HISTORIC AND DESIGN REVIEW COMMISSION

HDRC CASE NO: 2020-435
COMMON NAME: 1111 & 1115 N Palmetto
LEGAL DESCRIPTION: NCB 1302 BLK 3 LOT E 144.84 FT OF 10
ZONING: R-5, H
CITY COUNCIL DIST.: 2
DISTRICT: Dignowity Hill Historic District
APPLICANT: James Benfield/Benfield Real Estate
OWNER: James Benfield/Benfield Real Estate
TYPE OF WORK: Construction of two, 2-story residential structures
APPLICATION RECEIVED: September 28, 2020
60-DAY REVIEW: Not applicable due to City Council Emergency Orders
CASE MANAGER: Edward Hall

REQUEST:

SCALE: 1/4"=1'-0"

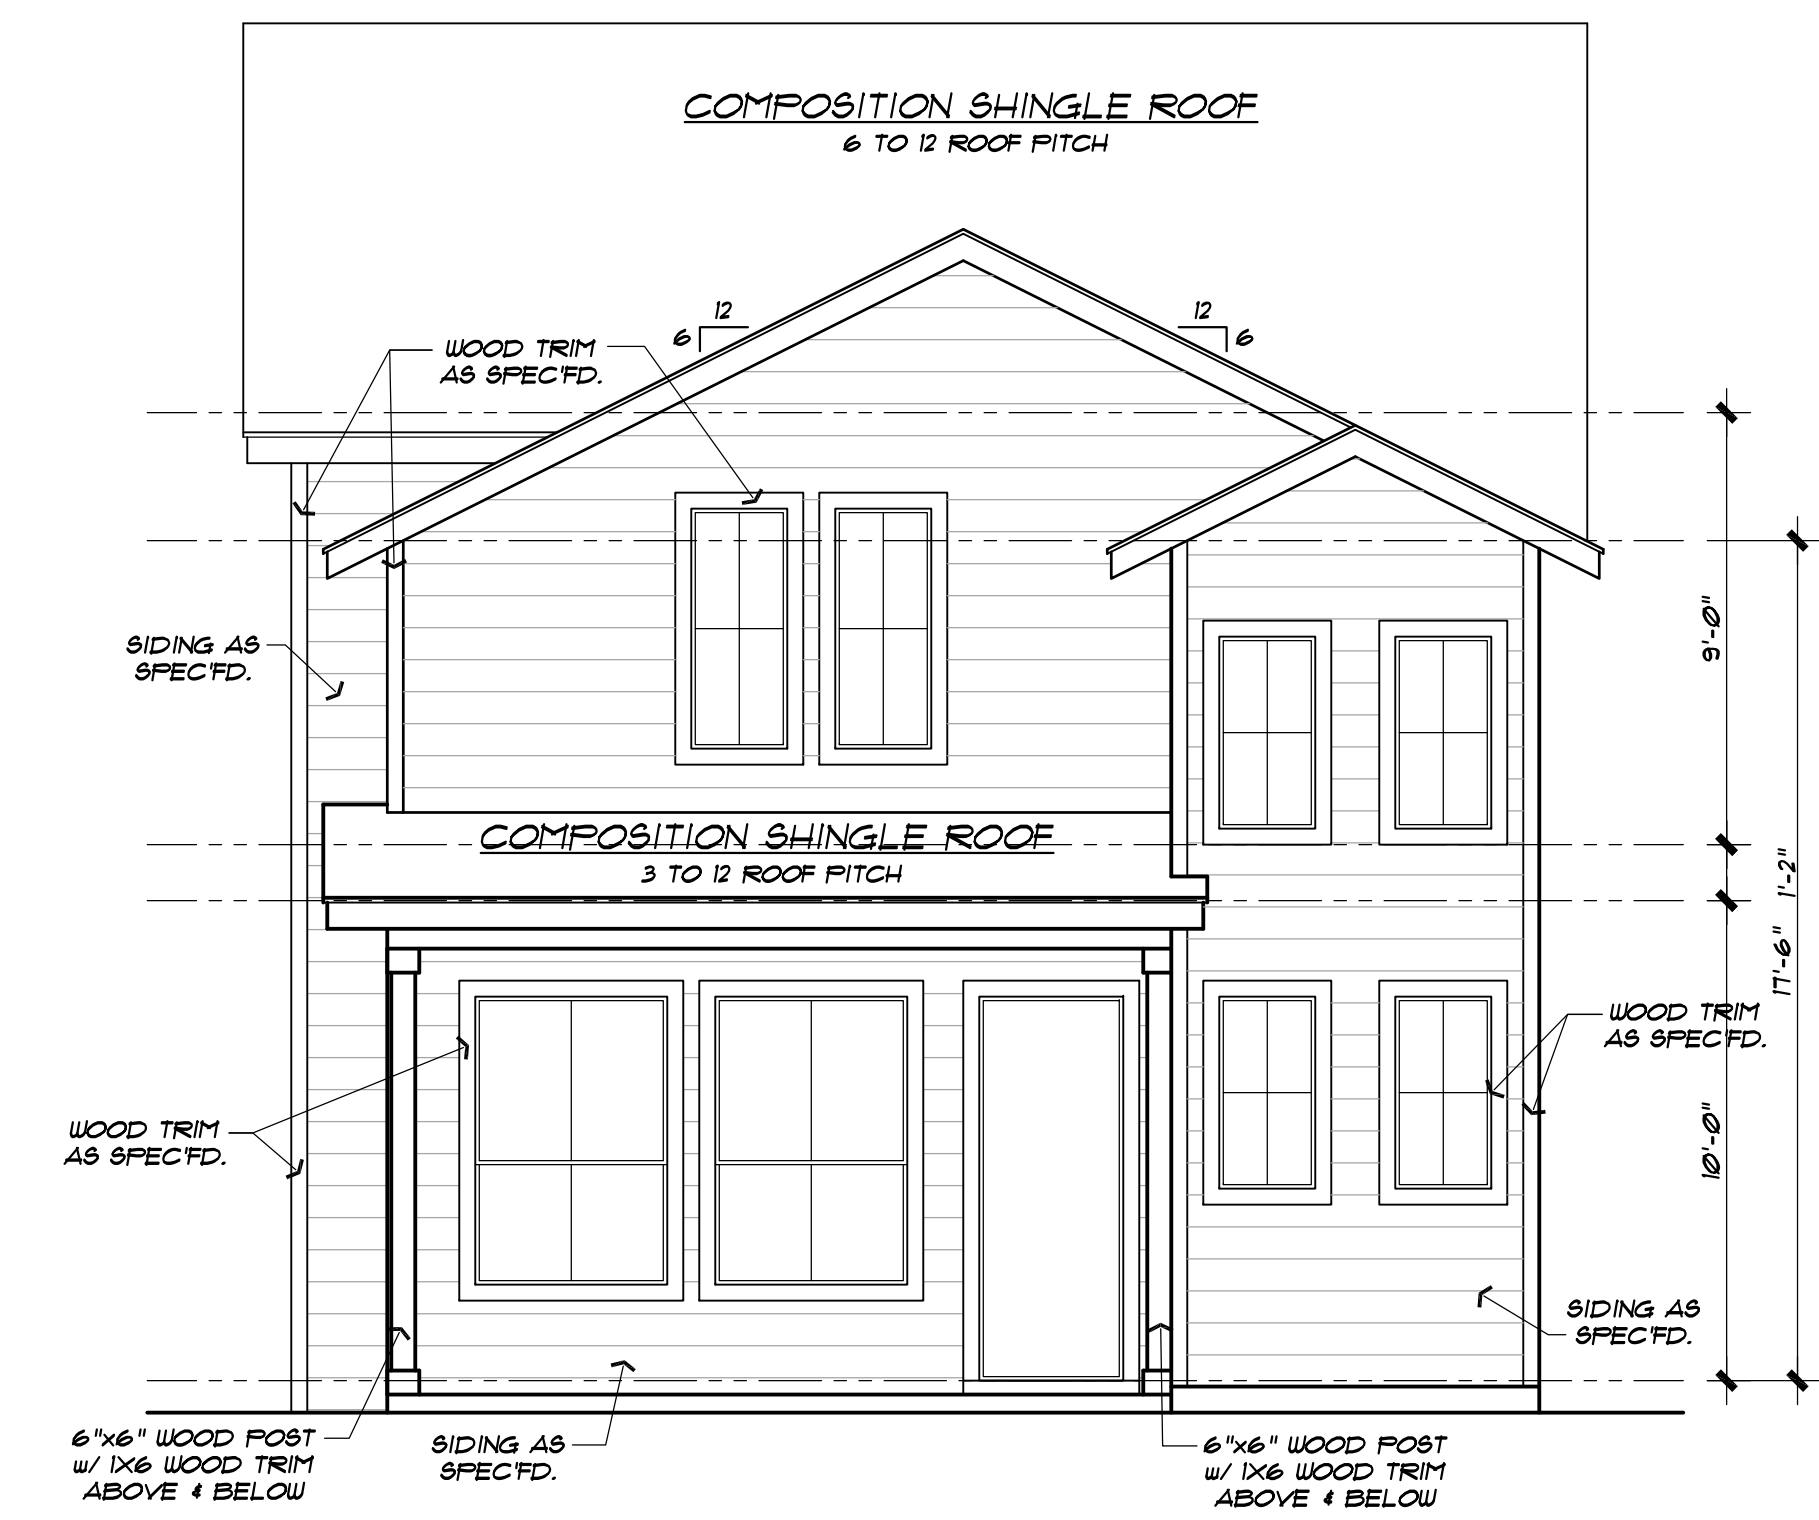
- 1b. **SCALE & MASS** – Per the Guidelines for New Construction 2.A.i., a height and massing similar to historic structures in the vicinity of the proposed new construction should be used. In residential districts, the height and scale of new construction should not exceed that of the majority of historic buildings by more than one-story. As noted in finding b, this block on N Palmetto features all one story structures. The applicant has proposed an overall height of approximately twenty-seven (27) feet. Because of the change in scale, staff finds that it would

- 1d. FOUNDATION & FLOOR HEIGHTS – Per the Guidelines for New Construction 2.A.iii., applicants should align foundation and floor-to-floor heights within one foot of floor-to-floor heights on adjacent historic structures. The applicant has not specified the exact foundation height. The applicant is responsible for complying with the Guidelines regarding foundation heights.

- 1e. ROOF FORMS – The applicant has proposed roof forms that include front and side facing gabled roofs. Staff finds the proposed roof forms to be appropriate and consistent with the Guidelines.

- 1f. WINDOW & DOOR OPENINGS – Per the Guidelines for New Construction 2.C.i., window and door openings with similar proportions of wall to window space as typical with nearby historic facades should be incorporated into new construction. Staff finds that all ganged and grouped windows should be separated by a mullion of at least six (6) inches in width. Additionally, staff finds that windows should be added to both the north and south facades near the front of both structures and that non-traditionally sized window openings should be eliminated, such as fixed square windows.

- 1g. PORCH MASSING – The applicant has proposed porch massing that is integral to the massing of both structures. Generally, staff finds the proposed porch massing to be appropriate; however, staff finds that the proposed porch depth should be increased to at least five (5) feet.

- 1l. ARCHITECTURAL DETAILS – As noted in finding 1f, staff finds that all ganged and grouped windows should be separated by a mullion of at least six (6) inches in width. Additionally, staff finds that windows should be added to both the north and south facades near the front of both structures and that non-traditionally sized window openings should be eliminated, such as fixed square windows. Additionally, staff finds that porches should be increased in depth to at least five (5) feet, as noted in finding 1g.

- i. That the applicant incorporate several design strategies to mitigate the visual impact of the additional height including utilizing a half story or an additional increase in front yard setback. as noted in findings 1b and 2b.

- ii. That foundation heights that are consistent with the Guidelines be utilized as noted in findings 1d and 2d.
- iii. That all ganged and grouped windows be separated by a mullion of at least six (6) inches in width. Additionally, staff recommends that windows should be added to both the north and south facades near the front of both structures and that non-traditionally sized window openings should be eliminated, such as fixed square windows, as noted in findings 1f and 2f.

- iv. That the applicant increase the porch depth to at least five (5) feet as noted in findings 1g and 2g.
- v. That the applicant install windows that meet staff's standards specifications as noted in findings 1j and 2j.

SITE PLAN

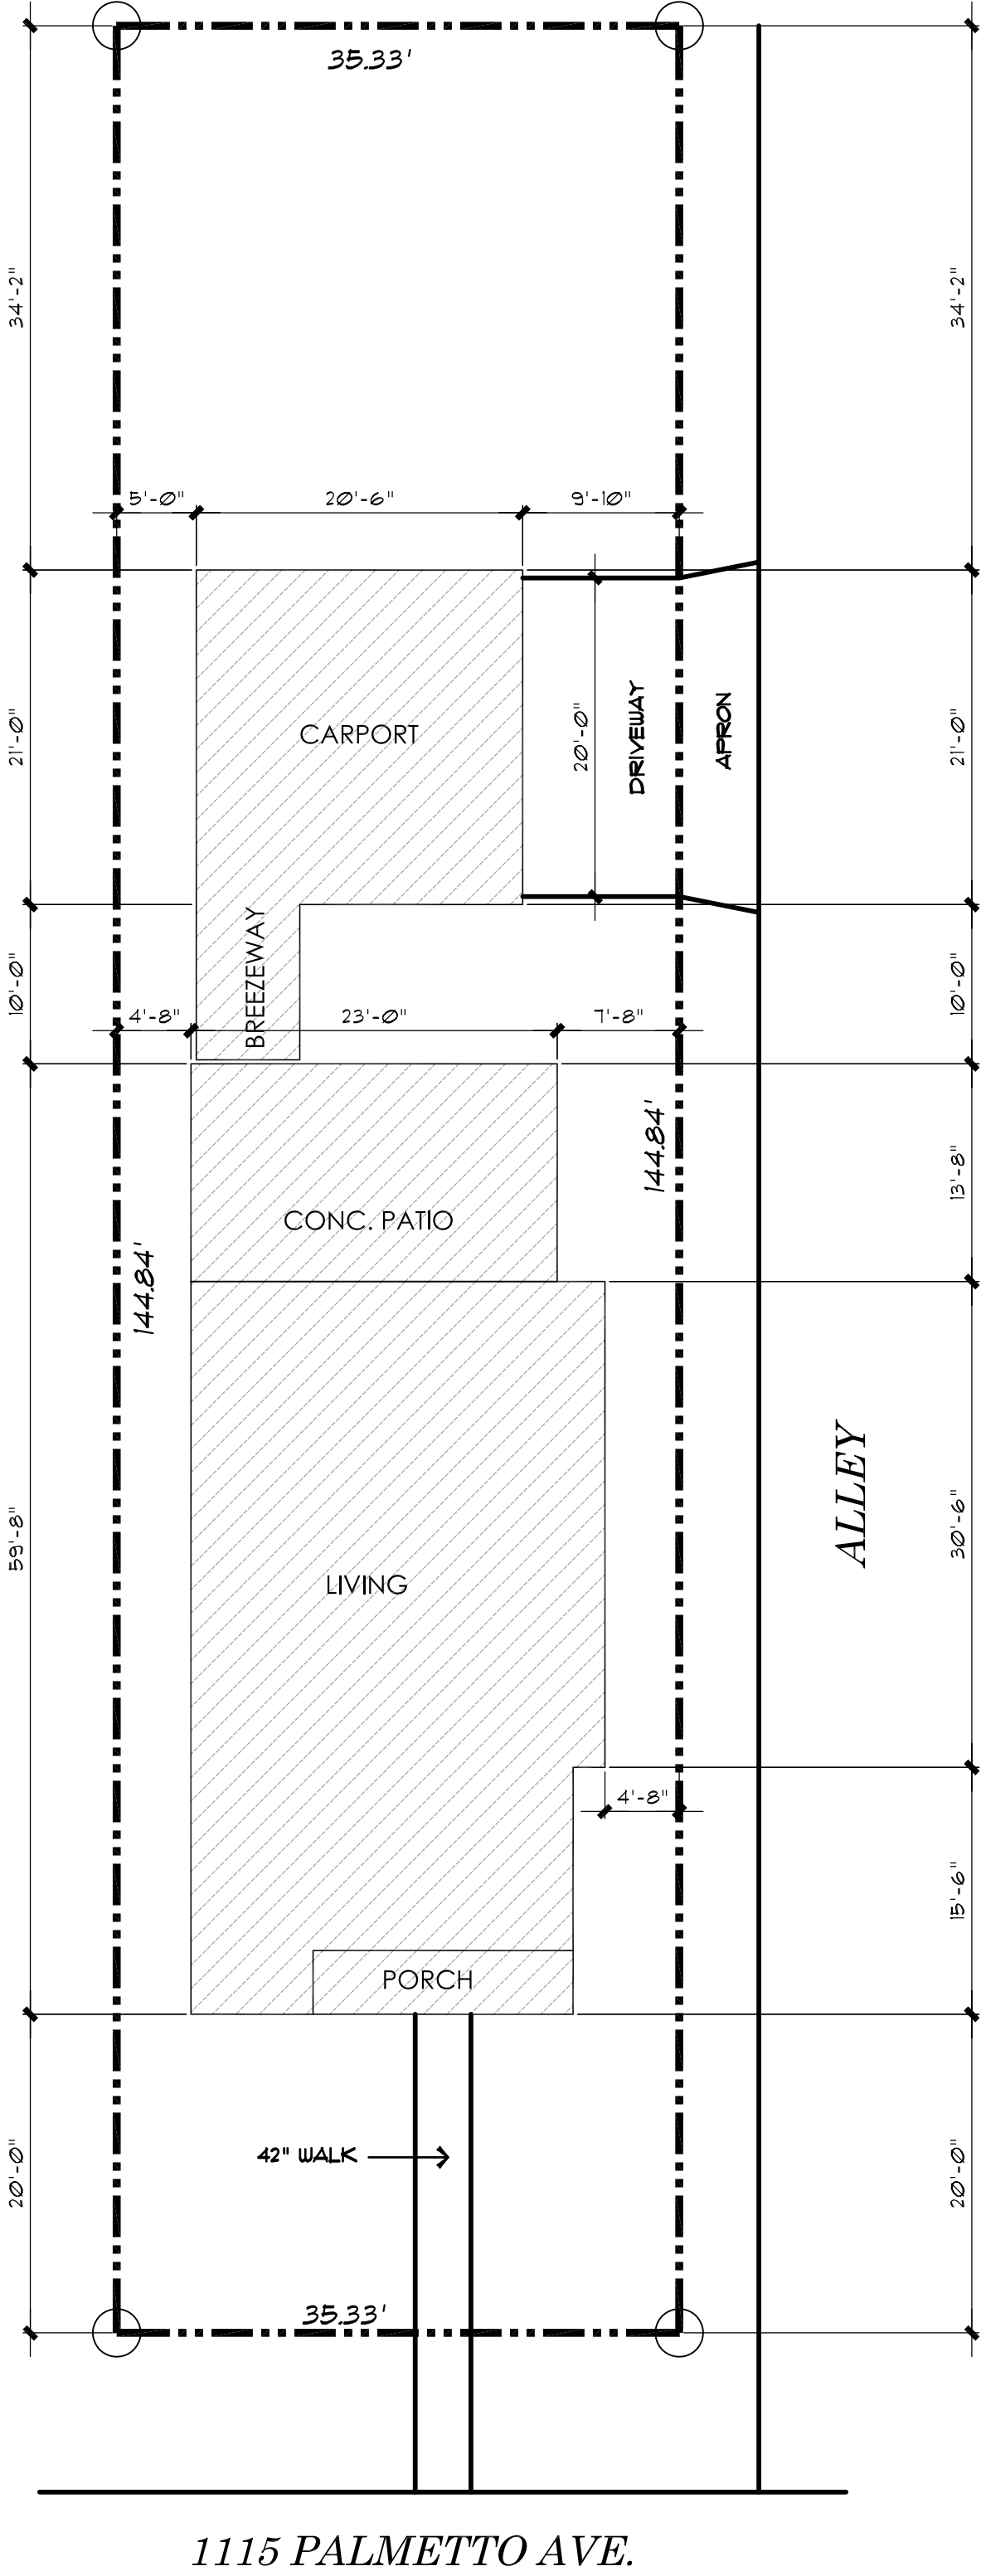
- 2a. **SETBACKS** – The applicant has proposed a setback of twenty (20) feet from the front property line. Additionally, the applicant has submitted a setback diagram noting a setback that is greater than all existing, historic setbacks on the block with the exception of one structure, the historic structure at the corner of N Palmetto and Sherman. Generally, staff finds that the proposed setback is appropriate and consistent with the Guidelines by responding to the setbacks of the most immediate historic structures.

- 2h. **LOT COVERAGE** – Per the submitted site plan, the proposed lot coverage is consistent with the Guidelines.
- 2i. **MATERIALS** – The applicant has proposed materials that include composite siding, asphalt shingle roofs, wood columns and wood trim. The proposed siding should feature an exposure of four inches, a smooth finish, a thickness of 3/4" and mitered corners. Columns should be six inches square and feature both capital and base trim as well as chamfered corners. The applicant is responsible for submitted a column detail to staff.

- 2n. SITE ELEMENTS (Driveways) – The applicant has proposed to access the rear carport with a driveway of twenty-one (21) feet in width. This is inconsistent with the Guidelines. Staff finds that the proposed driveway should be separated in width to be consistent with the Guidelines.

- 2o. WALKWAY – The applicant has proposed a concrete walkway to connect the front porch to the right of way. The applicant has proposed a width of forty-two (42) inches. This is consistent with the Guidelines.

- vi. That the proposed driveways be separated in width to be consistent with the Guidelines as noted in findings 1n and 2n.
- vii. That a detailed landscaping plan be submitted for review and approval as noted in findings 1p and 2p.
